Date: May 14, 2026
To: All Vendors
Subject: Addendum #1

REFERENCE: **B028-26 BPUB North Regional Force Main, Phase 1**

Project:	Brownsville PUB – North Regional Force Main Phase I BPUB Bid No. B02826	Addendum Date:	May 13, 2026
From:	John W. Clint, PE	Project No.:	47277.001

ADDENDUM No. 1

AERIAL CROSSING
PLAN AND PROFILE

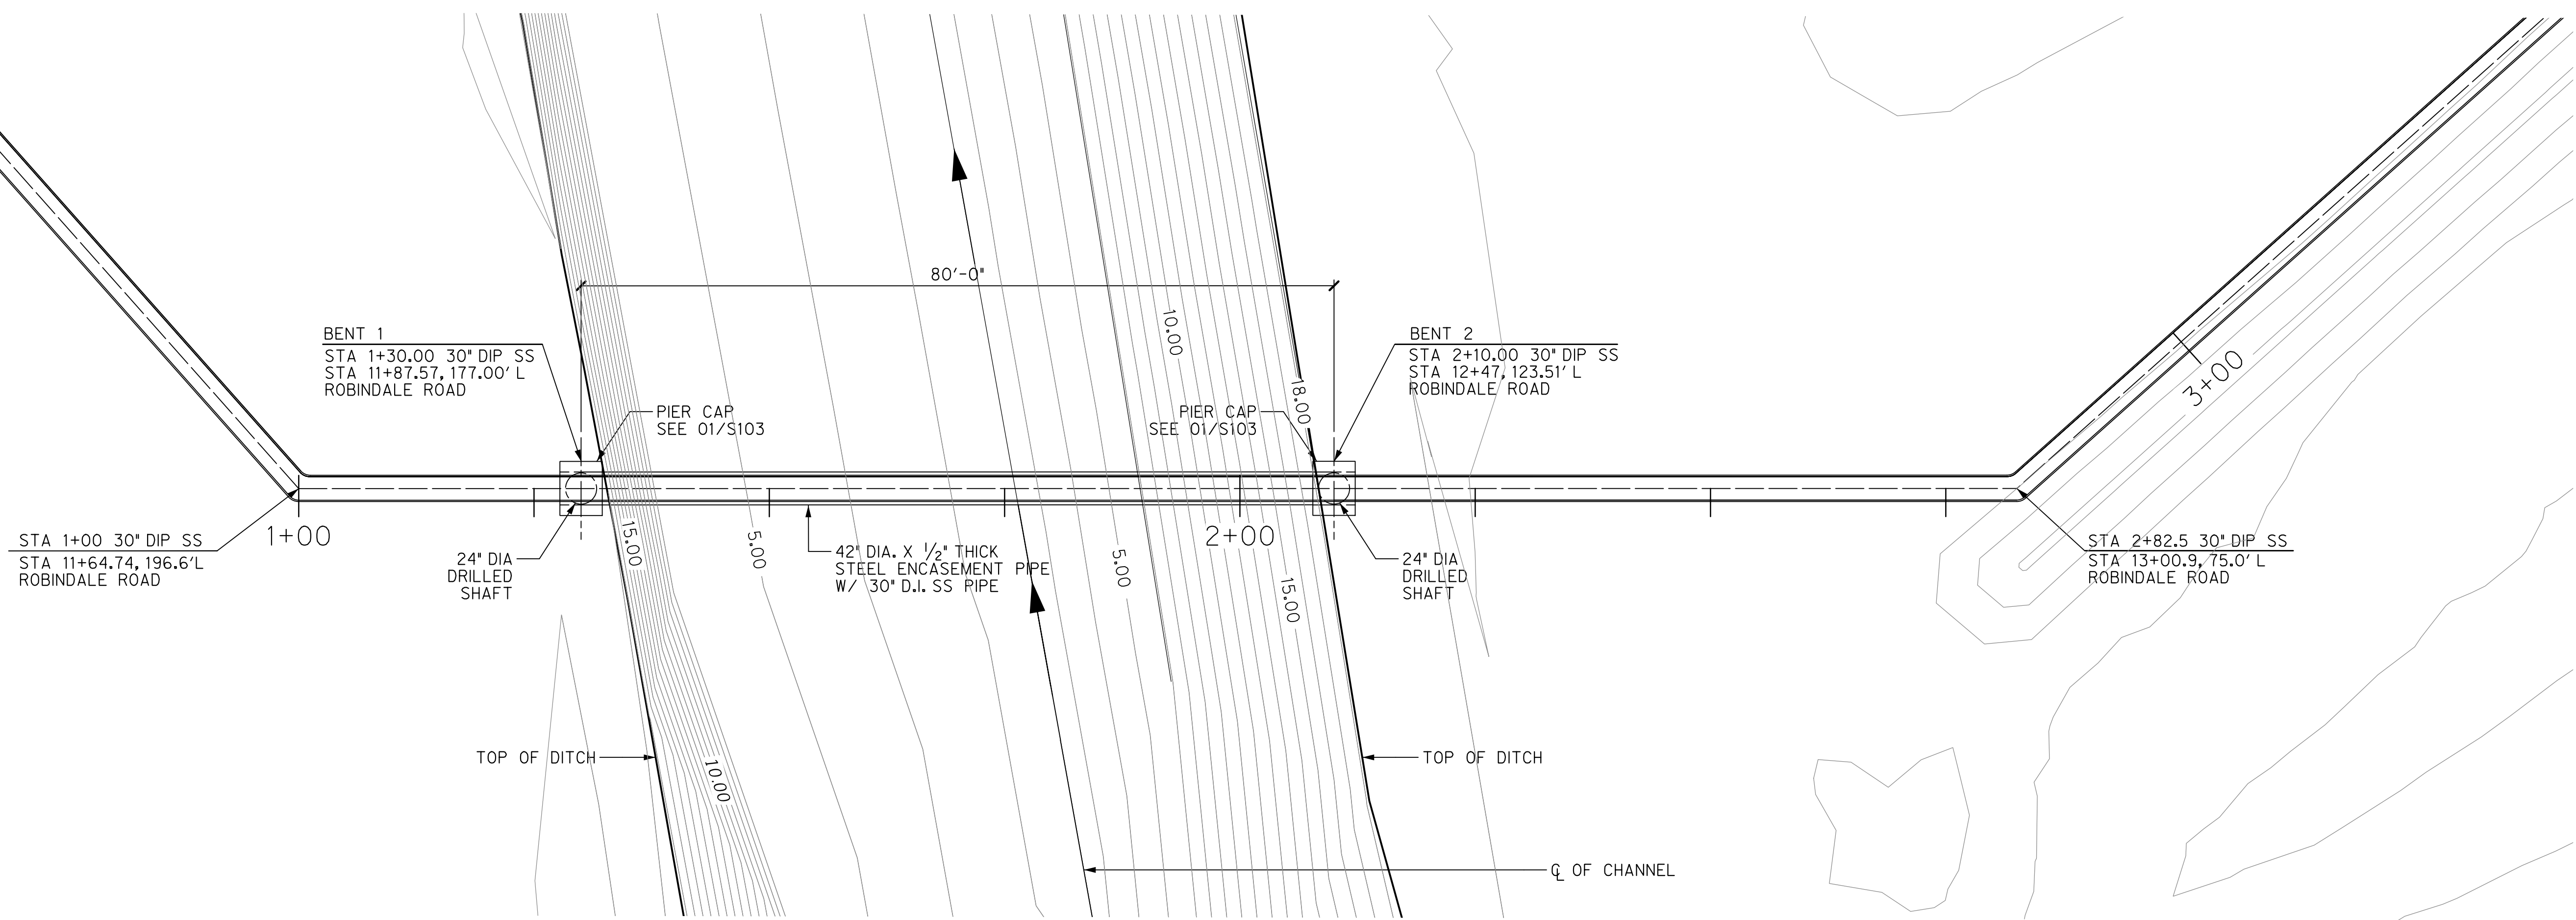
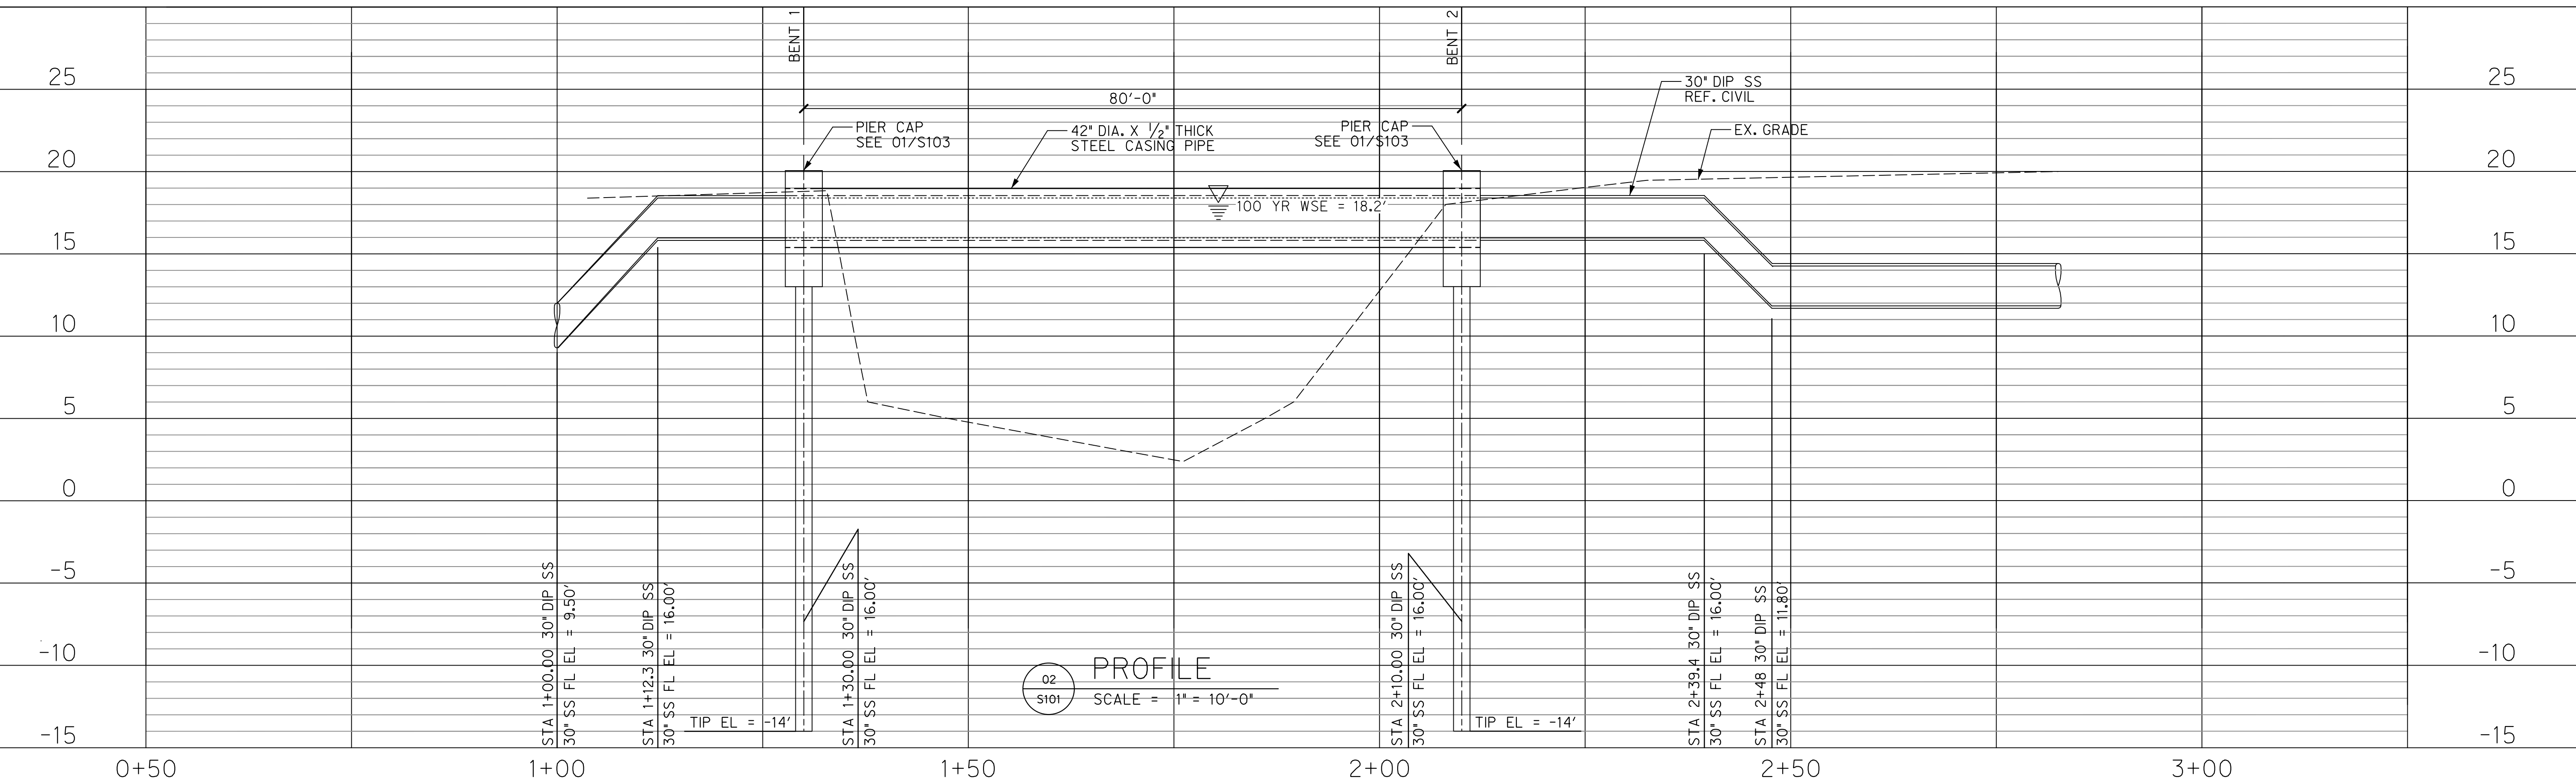
1. Revised sheet 1 to include structural plans (Attachment A).
2. Added sheets S101, S102 & S103 (Attachment A).
